ADDENDUM NO. 2

PROJECT NO. DGS C-0946-0012 PHASE 006

PROJECT TITLE - PA State Museum & PHMC Tower - Infrastructure Upgrades and Renovations

Design Resources Group Architects AIA
270 Davidson Ave, Suite 303
Somerset, NJ, 08873

DRAWN BY	DATE	DRAWING NUMBER
R. CLOSE <td>10.10.2025<td>A410</td></td>	10.10.2025 <td>A410</td>	A410
CHECKED BY <td>SCALE<td>AS NOTED</td></td>	SCALE <td>AS NOTED</td>	AS NOTED
D. VODZAK <td></td> <td></td>

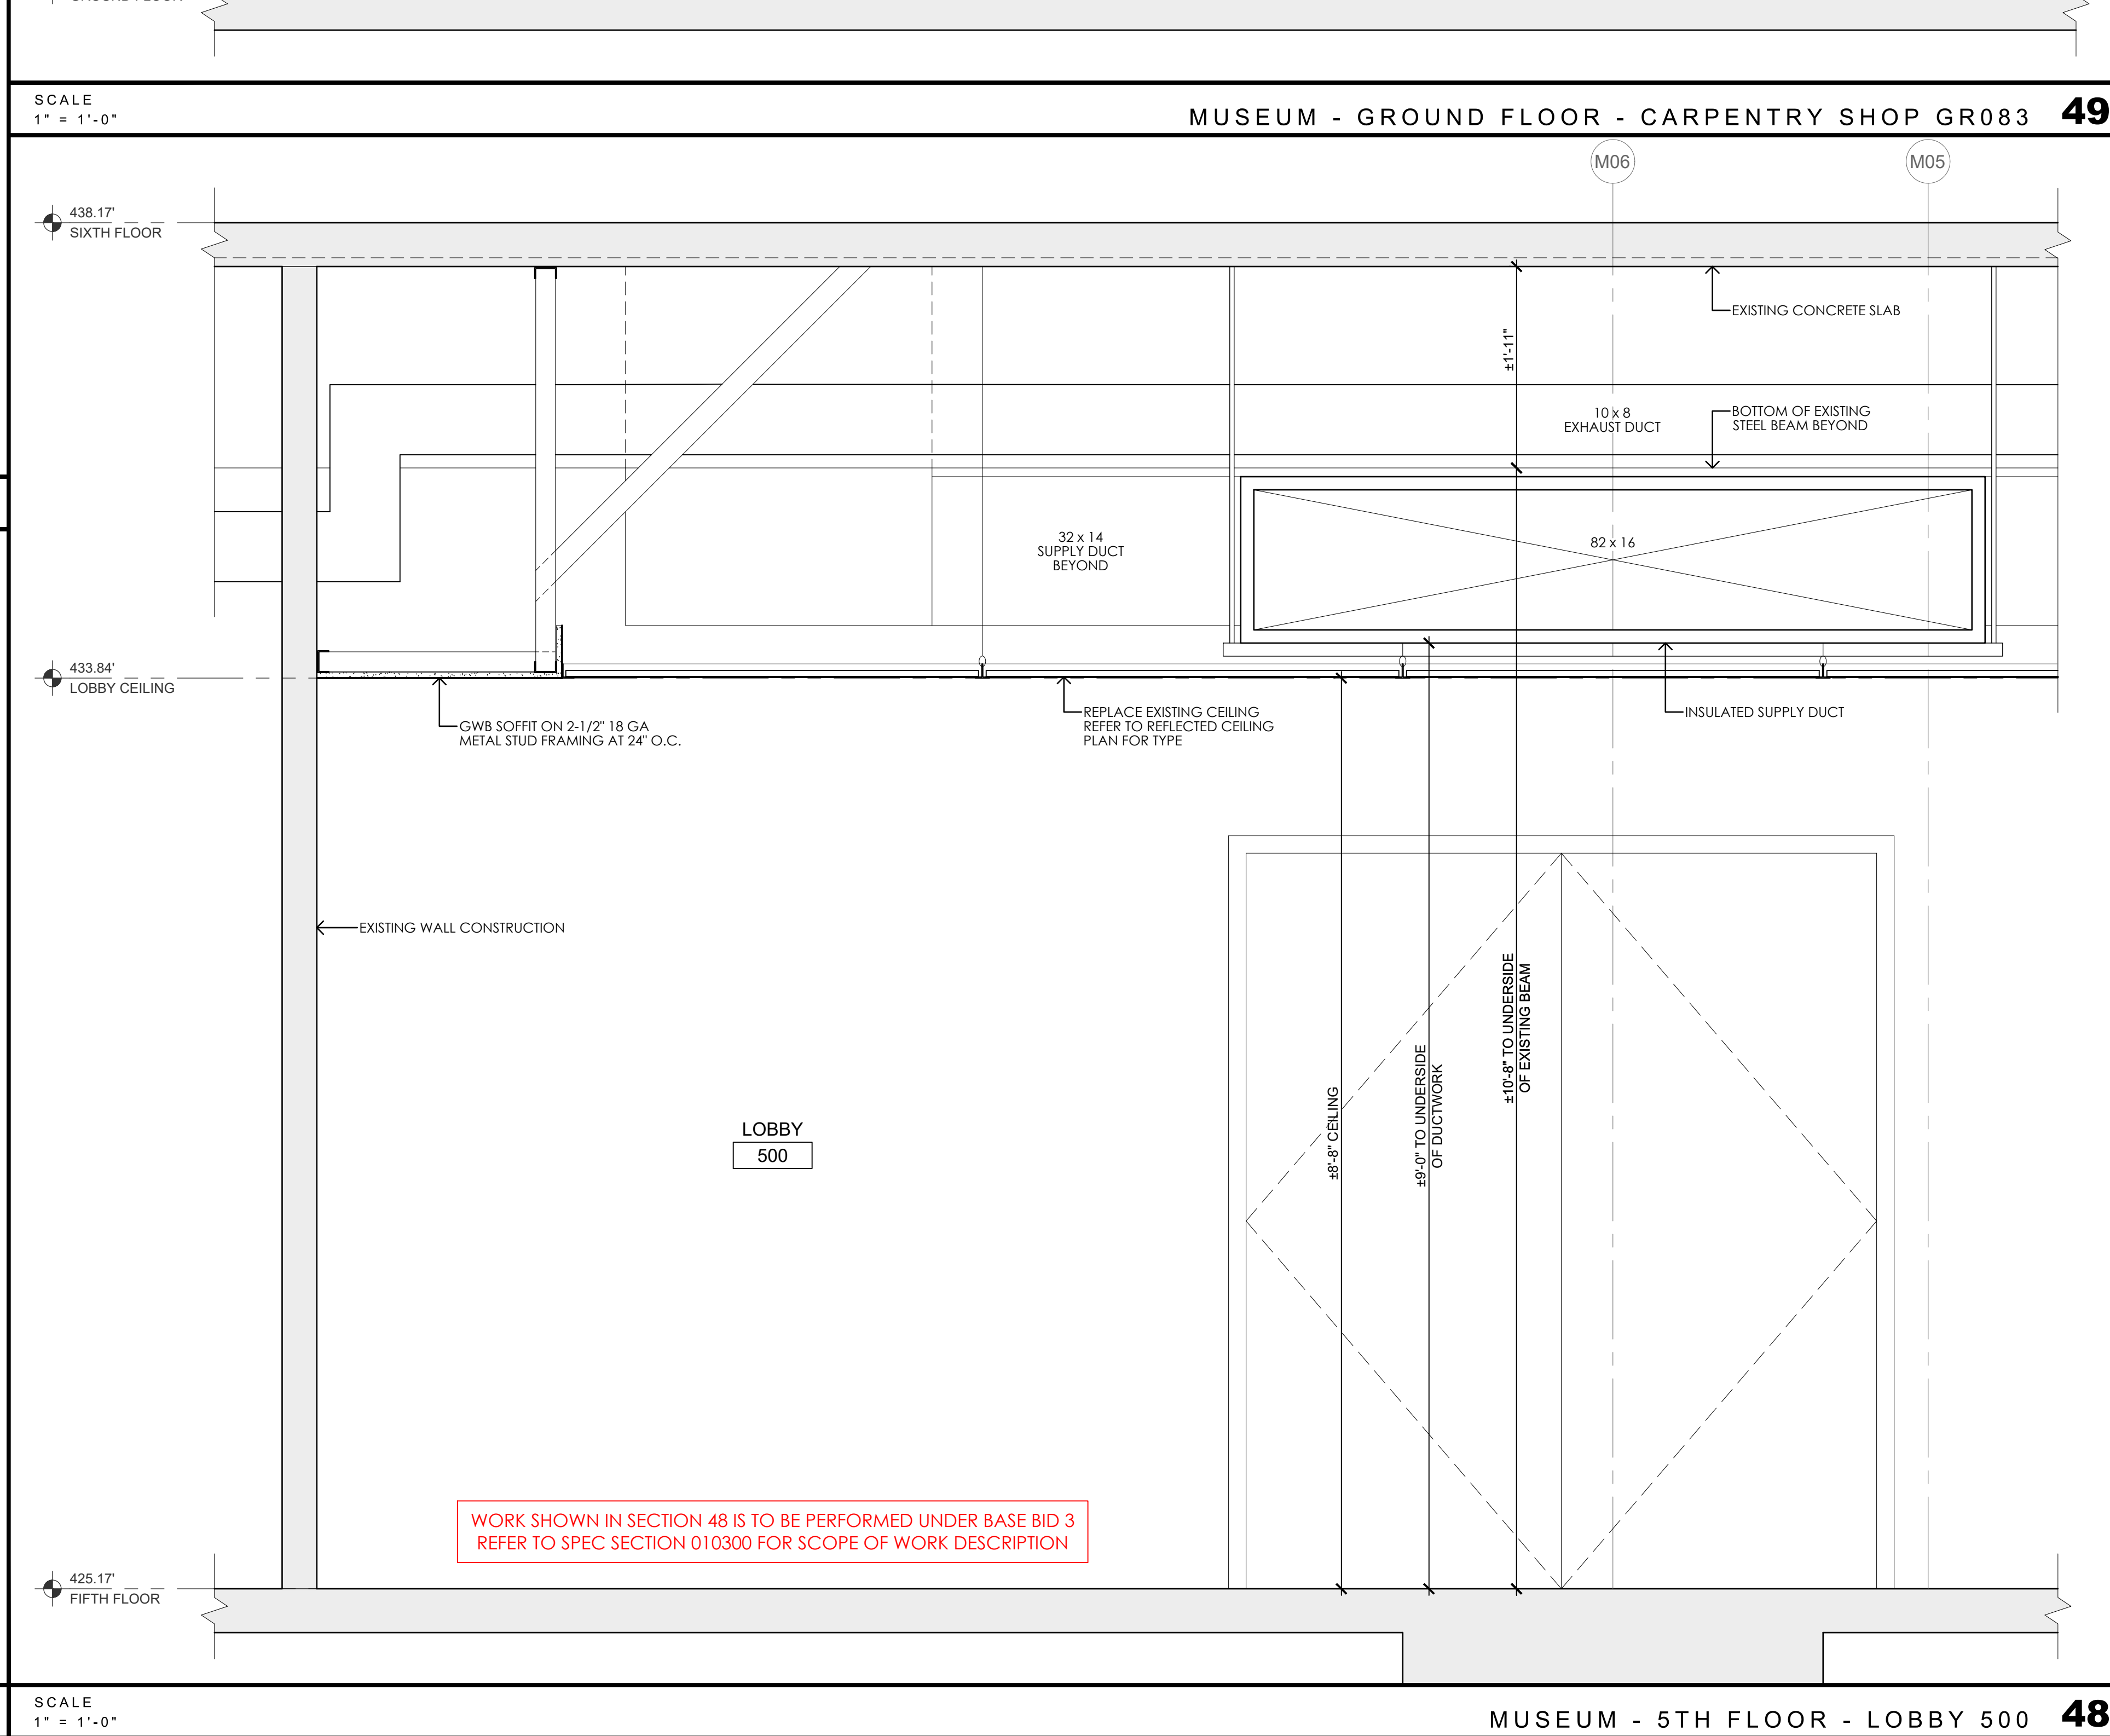
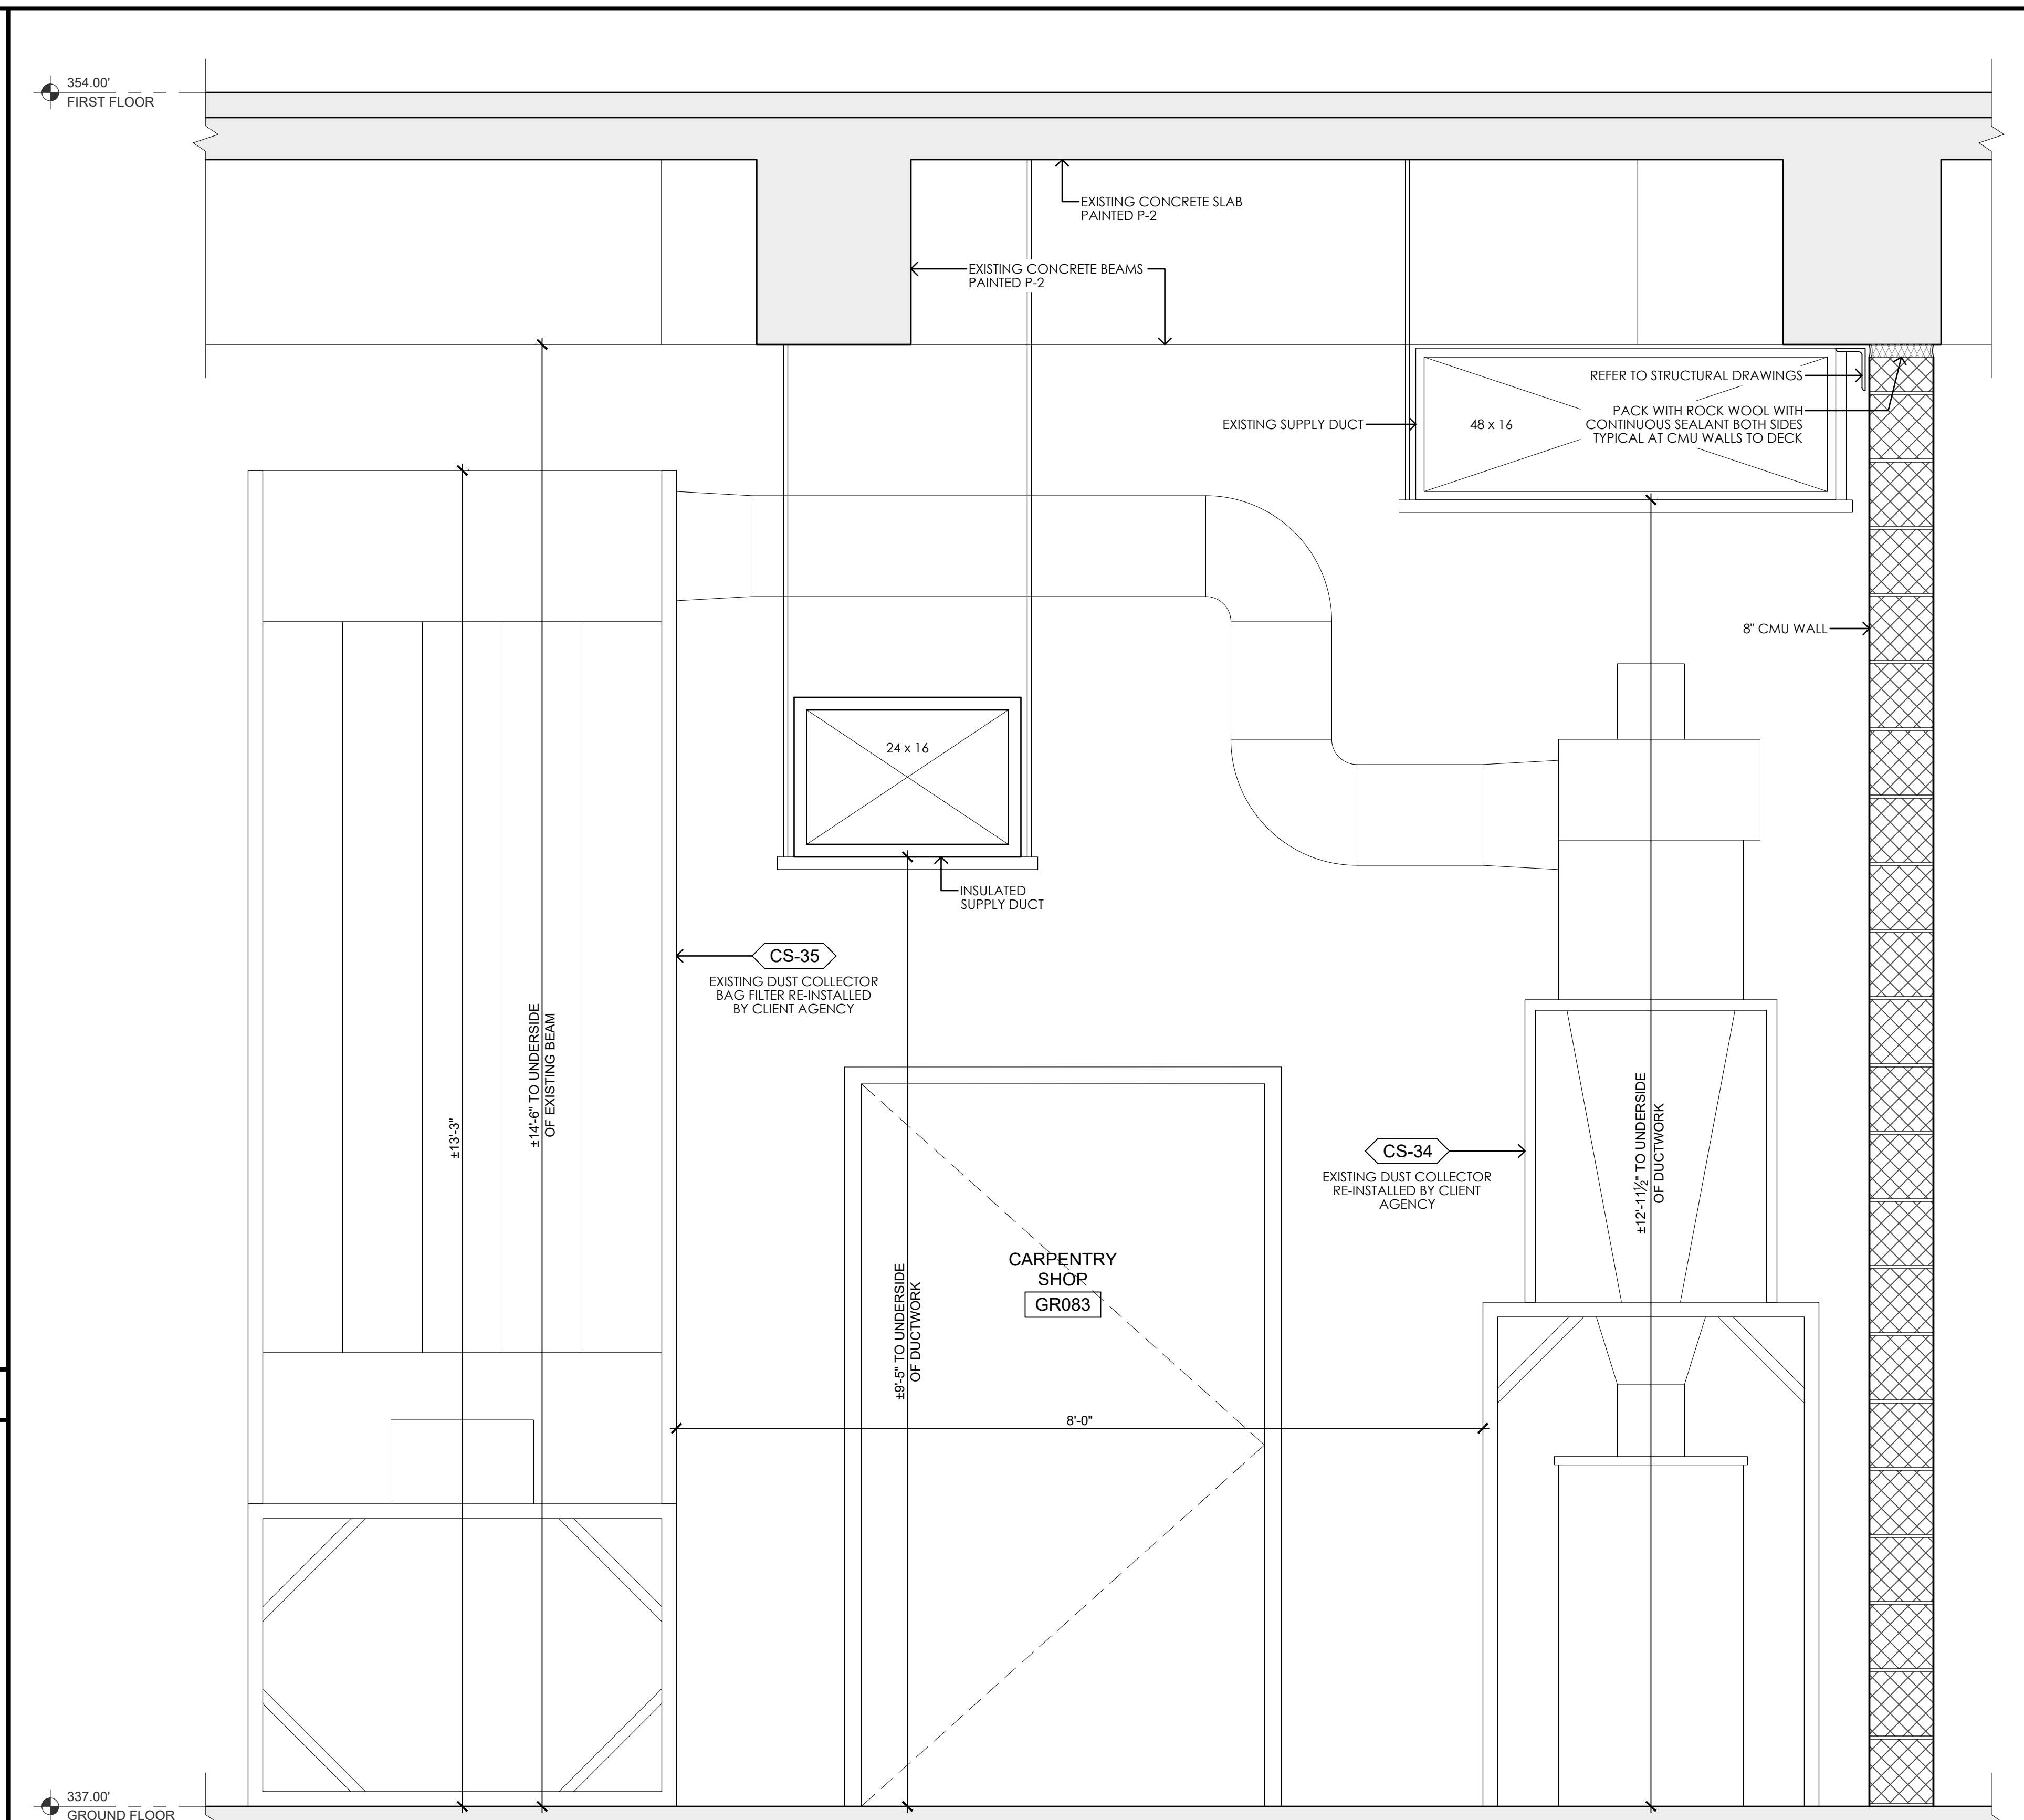
Item 26 - Drawing A410 - At Detail 47, corrected detail reference to 29/A424.
